PREPARED BY: A. DYE STAFF REPORT: SEPTEMBER 10, 2022 MEETING

APPLICATION NUMBER: 22-8013, 22-8034

ADDRESS: 3940 – 3942 THIRD

SCOPE: REHABILITATE BUILDING, ESTABLISH OUTDOOR SEATING AND SURFACE PARKING LOT

PROPOSED SITE PLAN

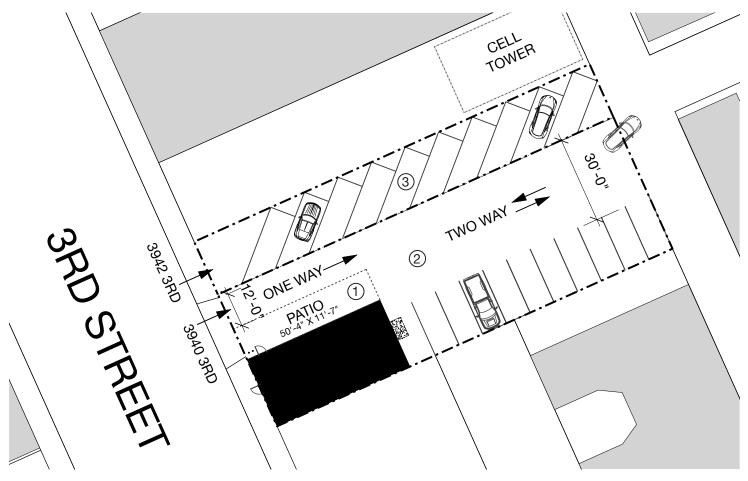
• The project includes the resurfacing of the existing gravel lots for surface parking and a patio. The existing wide curbcut extends from the northwest corner of the building to the corner of the proposed one-way lane entrance from Third Avenue.

- The front and north facades have paneling in addition to concrete block and will require extreme precision with the painting method to make sure a unified appearance extends across differing materials and elevations.
- The patio has not been fully designed within this application. The rendering on page 15 of the applicant's submission packet shows four bollards at the Third Avenue sidewalk, but it is not clear if any other enclosure is planned for the other two sides of the patio where cars will be actively moving across the surface lot. Cut sheets for the outdoor seating and bollards are needed, as well as cut sheets for any additional elements for the project (such as exterior lighting and additional patio enclosure).

• The final design for the patio and associated cut sheets for all exterior elements will be submitted to staff for review and approval prior to the issuance of the building permit.

NORTH AND FRONT FACADE

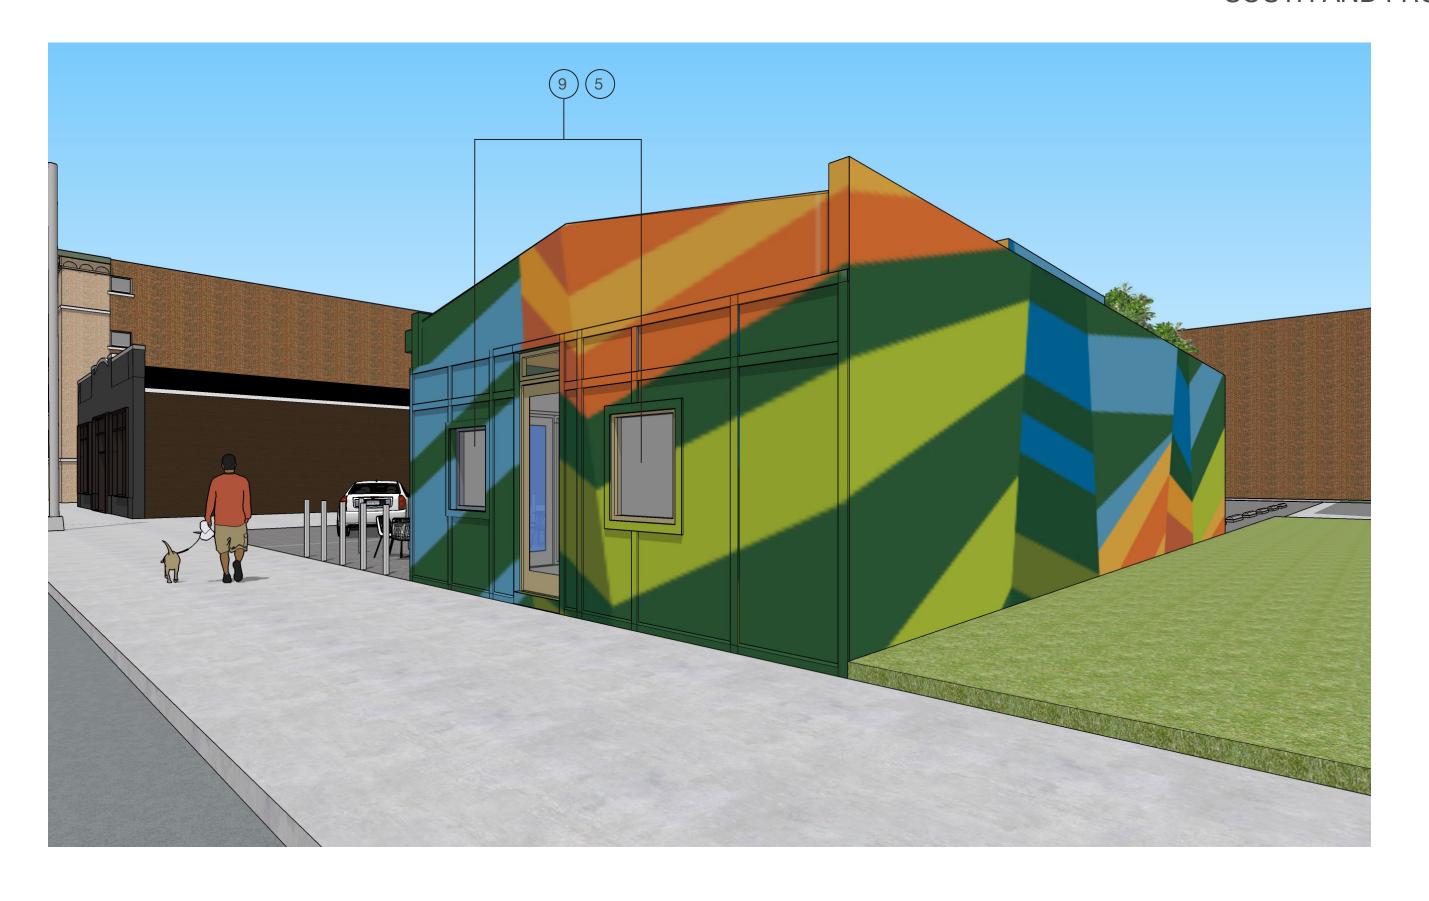
• It is staff's opinion that the proposed geometric mural wrapping the existing four sides of the structure and rooftop enclosures is a creative approach to the building's rehabilitation and adds a level of creativity currently lacking on the existing facades.
